1. Type of Well □ Oil Well ⊠ Gas Well □ Other					8. Well Name and No. WHITE CITY 14 1	
2. Name of Operator Contact: DAVID A EYLER CIMAREX ENERGY COMPANY OF CO-Mail: DEYLER@MILAGRO-RES.COM					9. API Well No. 30-015-24865-00-S1	
3a. Address 202 S CHEYENNE A TULSA, OK 74103.4	E 1000	3b. Phone No. (include area code) Ph: 432-687-3033	e) 10. Field and Pool, or Exploratory WHITE CITY		Exploratory	
<u>, , , , , , , , , , , , , , , , , , , </u>	, R., M., or Survey Description	ו ו)			11. County or Parish, and State	
Sec 14 T25S R26E S	50FNL 1650FEL		EDDY COUN		Y, NM

Permanent Abandonment of Federal Wells Conditions of Approval

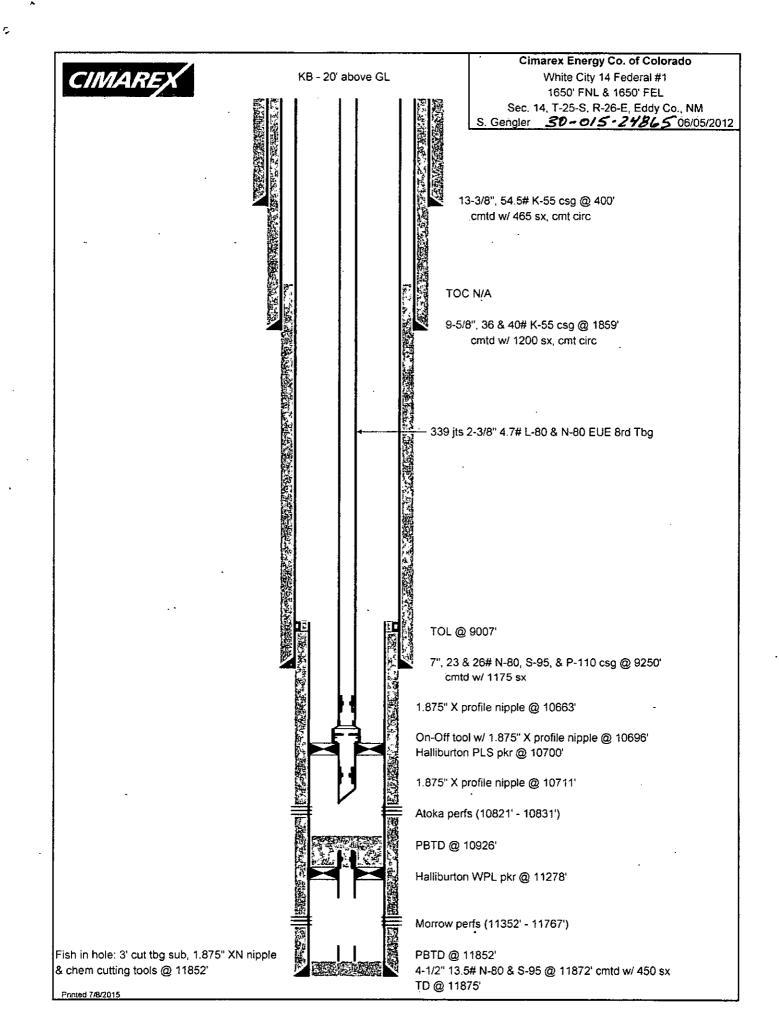
determined that the site is t 1) SET 4-1/2" CIBP (2) PUMP 50 SXS CM 3) PUMP 50 SXS CM 4) PUMP 45 SXS CM 5) CUT X PULL 7" CS 6) PUMP 130 SXS CI 7) PUMP 85 SXS CM 8) MIX X CIRC. TO S 9) DIG OUT X CUT O DURING THIS PROC THE REQUIRED DIS RECLAMATION PROC	d. Final Ab ready for fi ? 721 @10 ;700 '; <u>11. @ 9.3</u> 11. @ 8,6 11. @ 9.3 11. @ 450 SURF. 25 DFF WEL CEDURE SPOSAL,	andonment Notices shall be fil nal inspection.) (PUMP 25 SXS.CMT.@1 00'-8.957'(7"CSG.SHOE 84'-8,504'(T/WC); WOC 37'-5,387'(T/B.S.); WOC -1 ,859' , 1909' 210'-1,809'(T/DLWR.,B// D'- 270'(T/ANHY.,13-3/8 "C SXS.CMT.@ 63-37 LHEAD 3' B.G.L.; WELD	sults in a multiple completion or rece ed only after all requirements, includ 0,72(<u>0,790'-10,525'(T/STWN); CIR 4-1/2"I NR TOP): WOC X TA</u> X TAG CMT. PLUG. X TAG CMT. PLUG. X TAG CMT. PLUG: ANHY.7"CSG.STUB,9-5/8"SH SG.SHOE); WOC X TAG CM Sur F ON STEEL PLATE TO CSGS CLOSED-LOOP SYSTEM W. I7. SEE ATTACH	OE); TAG. IT. PLUG. S. X INSTAL IED FOI	iew interval, a Form 316 , have been completed, (for 9300' & Su Contract Plug S L DRY HOLE MARI ANK AND HAUL C	4 so - Surf 450 - Surf (High Karst)

determined that the site is t 1) SET 4-1/2" CIBP (2) PUMP 50 SXS CM 3) PUMP 50 SXS CM 4) PUMP 45 SXS CM 5) CUT X PULL 7" CS 6) PUMP 130 SXS CM 7) PUMP 85 SXS CM 8) MIX X CIRC: TO S 9) DIG OUT X CUT C DURING THIS PROC THE REQUIRED DIS	d. Final Ab ready for fi ? 721 @10; 70 0'; <u>11.</u> @ 9.3 11. @ 8,6 11. @ 5,5 SG. @ +/- MT. @ 250 SURF. 25 DFF WEL CEDURE CEDURE SPOSAL, CEDURE	andonment Notices shall be fil nal inspection.) PUMP 25 SXS.CMT.@1 00'-8.957'(7"CSG.SHOE 84'-8,504'(T/WC); WOC 37'-5,387'(T/B.S.); WOC -1 ,859' .1909' 210'-1,809'(T/DLWR.,B// 2'-270'(T/ANHY.,13-3/8"C SXS.CMT.@62-3'- LHEAD 3' B.G.L.; WELD WE PLAN TO USE THE PER OCD RULE 19.15.1 true and correct. Electronic Submission #	sults in a multiple completion or rece ed only after all requirements, includ 0,72(<u>0,70</u> 0'-10,525'(T/STWN); CIR <u>4-1/2"I NR TOP): WOC X TA</u> X TAG CMT. PLUG. X TAG CMT. PLUG. X TAG CMT. PLUG: ANHY 7"CSG STUB,9-5/8"SH SG SHOE); WOC X TAG CM Sur F ON STEEL PLATE TO CSGS CLOSED-LOOP SYSTEM W. I7. SEE ATTACH CONDITION! 308687 verified by the BLM Wel	C.WELL. G.CMT. G.CMT. OE): TAG. IT. PLUG. X. INSTAL A STEEL T IED FOF S.OF AF	iew interval, a Form 316 have been completed, (for 9300 + 50 Contract Plags L DRY HOLE MARI ANK AND HAUL C PROVAL	4 so - Surf 4 so - Surf (High Karst KER.
